DEVELOPMENT ASSESSMENT PANEL REPORT

Application No.	DA/2023/0945
Address	187 Enmore Road ENMORE
Proposal	Partial demolition of existing structures and alterations and additions to an existing commercial building to create a 4 storey mixed use shop top housing development including 4 residential apartments
Date of Lodgement	14 November 2023
Applicant	John Drivas
Owner	John Drivas, Georgina Drivas, Stella Drivas, Athanasia-Nectaria Drivas, Theodore Drivas and Marios Koulouris
Number of Submissions	Initial: 1
Cost of works	\$1,595,000.00
Reason for determination at Planning Panel	SEPP 65 development
Main Issues	Compliance with ADG requirements Variation to FSR development standard
Recommendation	Approved with Conditions
Attachment A	Recommended conditions of consent
Attachment B	Plans of proposed development
Attachment C	Section 4.6 Exception to Development Standards
Attachment D	Architectural Excellence & Design Review Panel Meeting Minutes & Recommendations

1. Executive Summary

Figure 4: 3D diagram of the neighbouring site (no. 185 Enmore Road) showing the location of windows and doors.

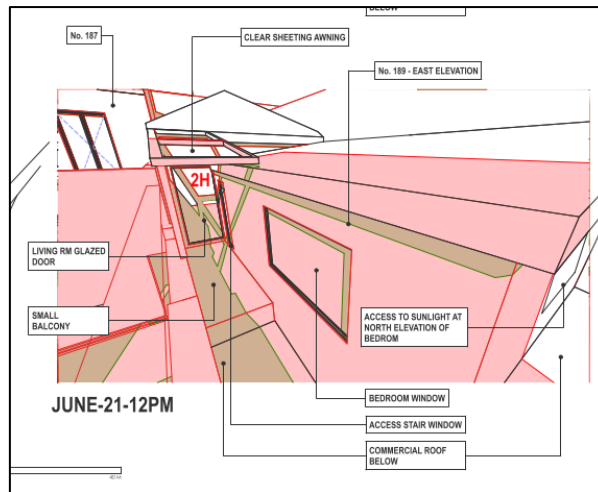
- The impacted door servicing the first-floor principal living area is located within relatively close proximity of the boundary (approximately 300mm), which in this case, makes compliance or near compliance more difficult (see Figure 4 below); and
